RE: TEDS Exception No. 18-03, for Intersection Spacing at Monarch glen Subdivision, 626  
30 Road

**DESIGN EXCEPTION #DE18-03**

**RE: Traffic Engineering Design Standards (TEDS) Exception Request  
Section 4.1.1, Access Locations - Spacing  
Monarch Glen Subdivision – 626 30 Road**

PRELIMINARY PLAN

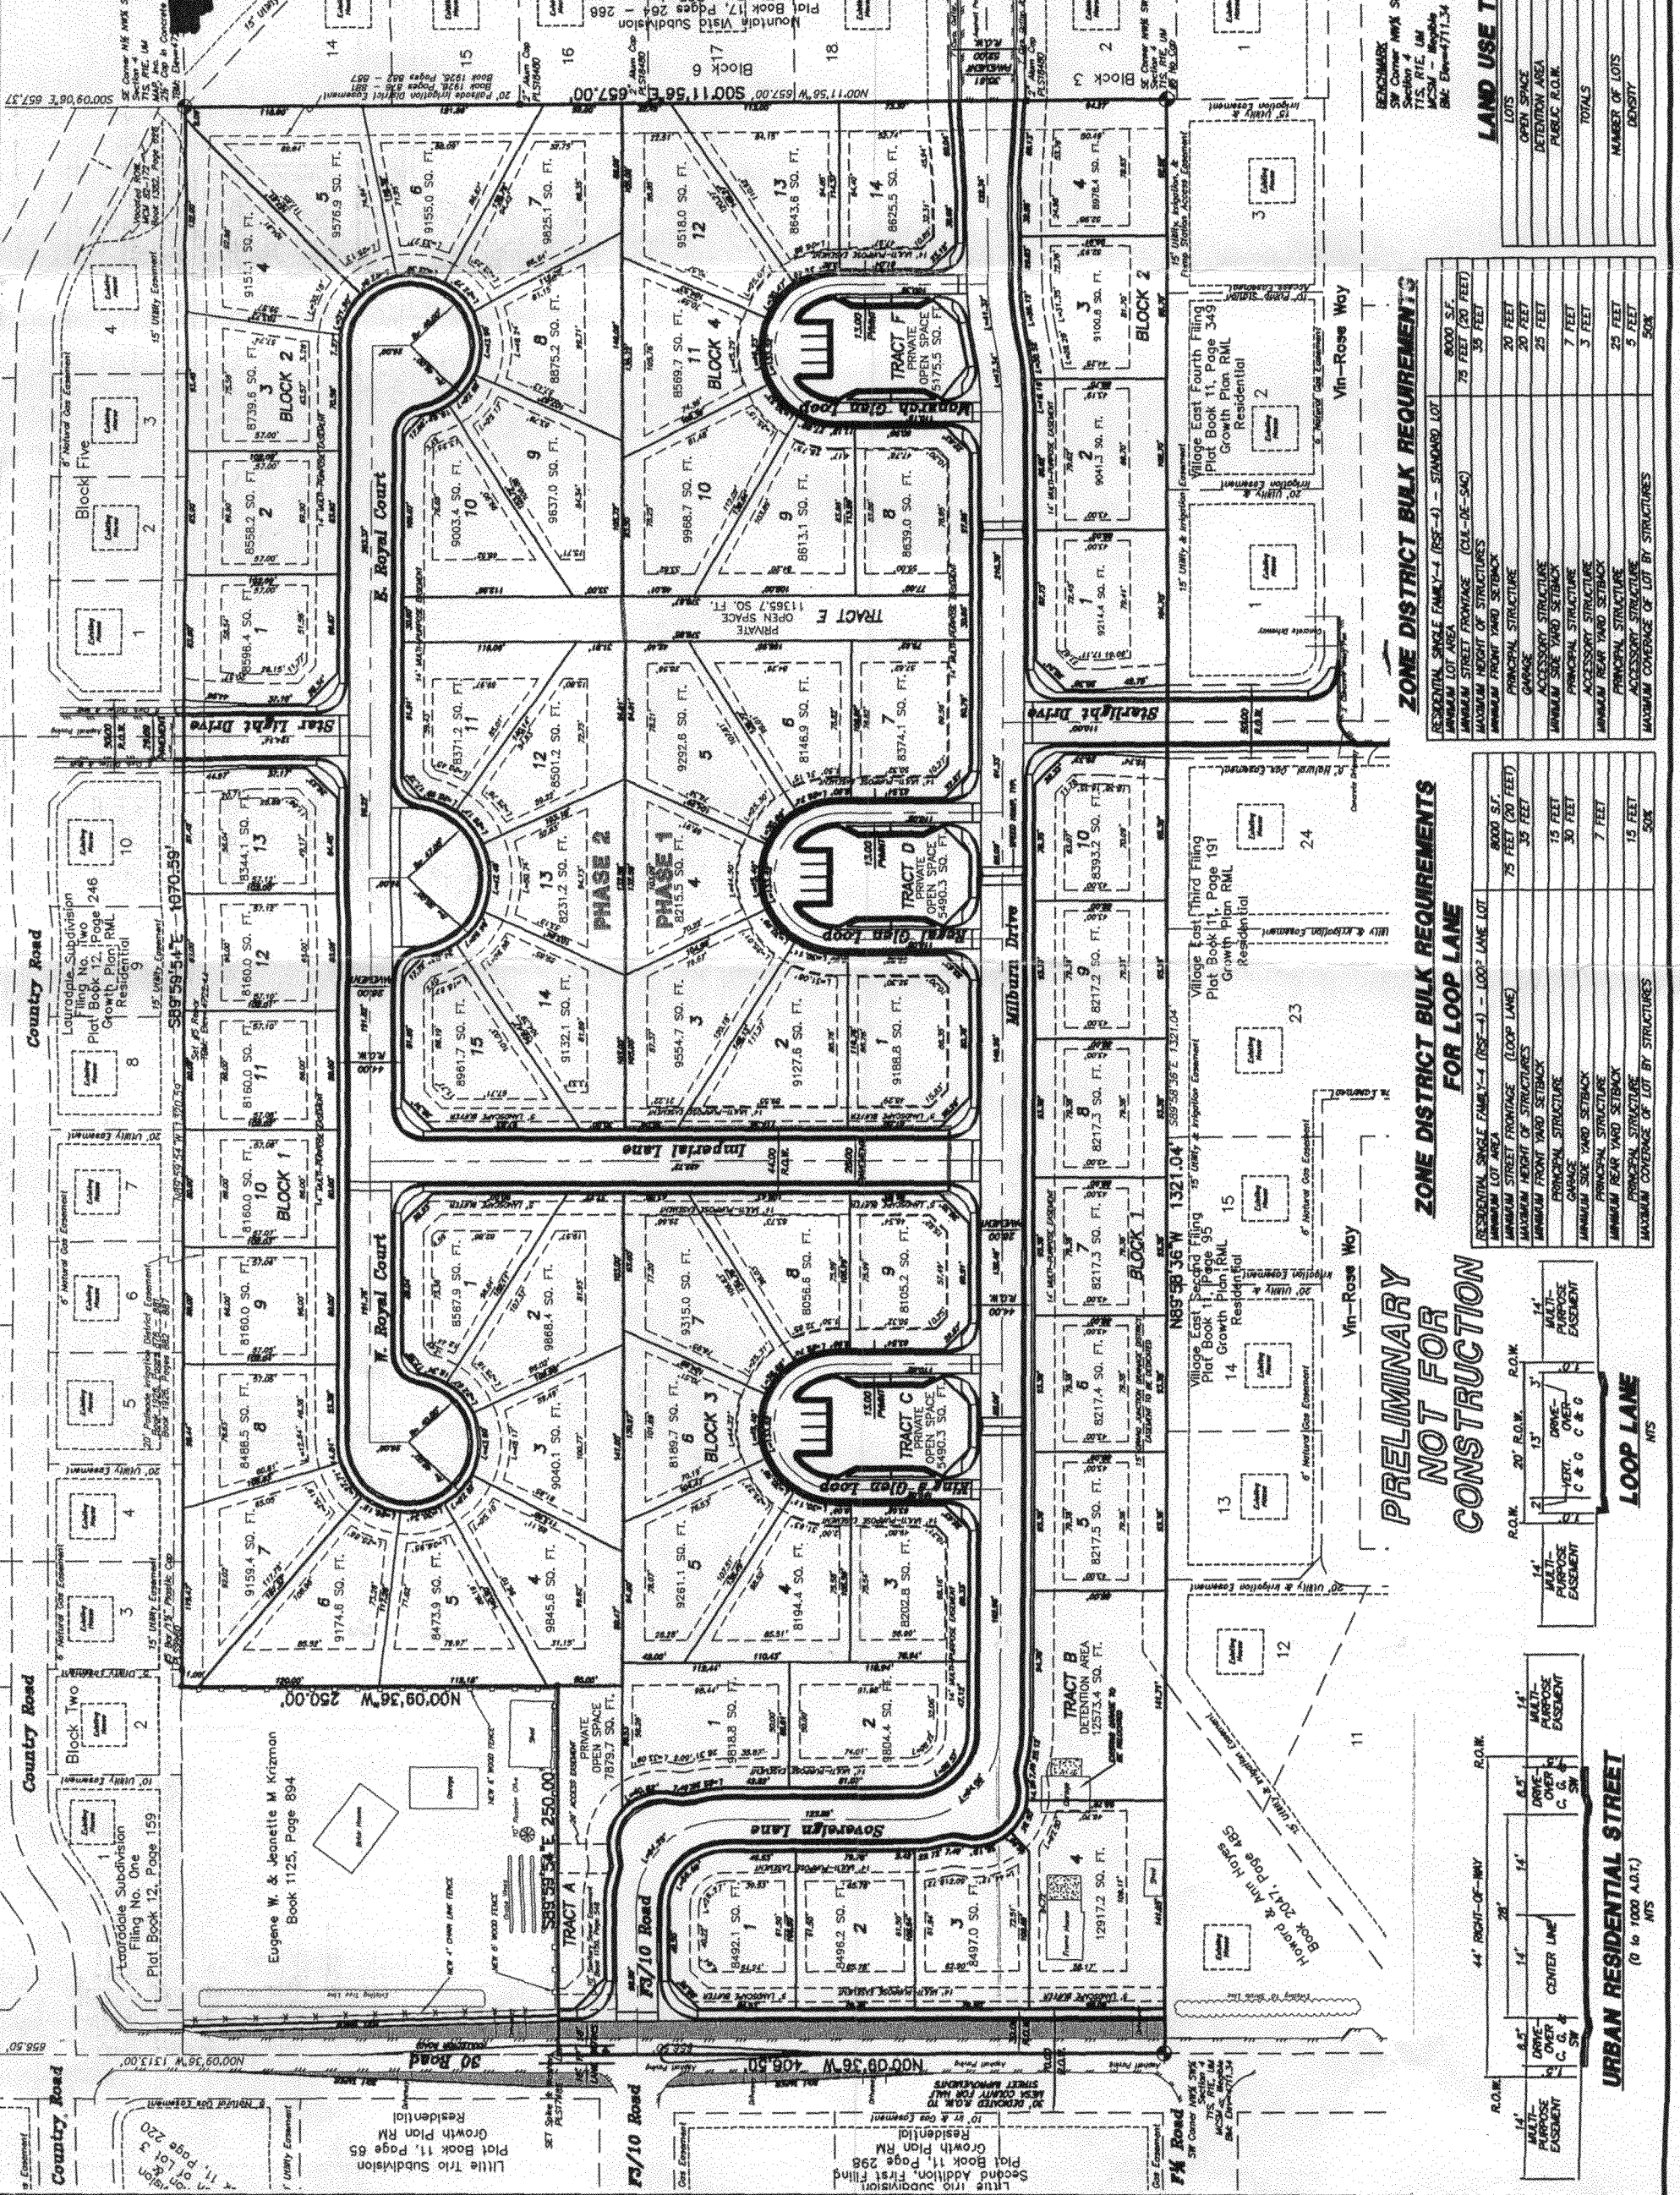
east King's Glen Loop – Imperial Lane	138.49'
<del>west</del> Regal Glen Loop – Imperial Lane	149.26'
<del>west</del> Regal Glen Loop – Starlight Drive	146.33'
east Regal Glen Loop – Starlight Drive	61.33'

1. East King's Glen Loop to Imperial Lane (138.49') While this is 11.5' short of our standard, the spacing could be improved by adjusting lot lines slightly and gain perhaps 5' – 7' and still meet lot size requirements. Leaving as-is would not produce conflicting movements.
2. West Regal Glen Loop to Imperial Lane - This is marginally (less than 1') from our standard. Adjustment of this would make other situations worse, and I think exception should be granted.
3. West Regal Glen Loop to Starlight Drive - This is marginally (less than 5') from our standard. Adjustment of these would make other situations worse, and I think exception should be granted.
4. East Regal Glen Loop to Starlight Drive – This is by far the worst spacing situation of the situations presented. I think a revised site layout could solve the problem.

Exception is for a waiver for current TEDS access spacing for a residential street. The points in question deal with spacing between the intersections of King's Glen Loop and Imperial Ln, and between Regal Glen Loop and Starlight Dr, with each pair being within 150' of its adjacent access.

I recommend approval of the requested Design Exceptions to Sections 4.1.1, *Spacing* and 4.1.2, *Offsets*, to allow a reduced spacing between the proposed and existing intersections.

There is no concern with this issue. Currently the access spacing requirement is being lowered to 50' for residential streets, and I see no related safety issue for these intersections.
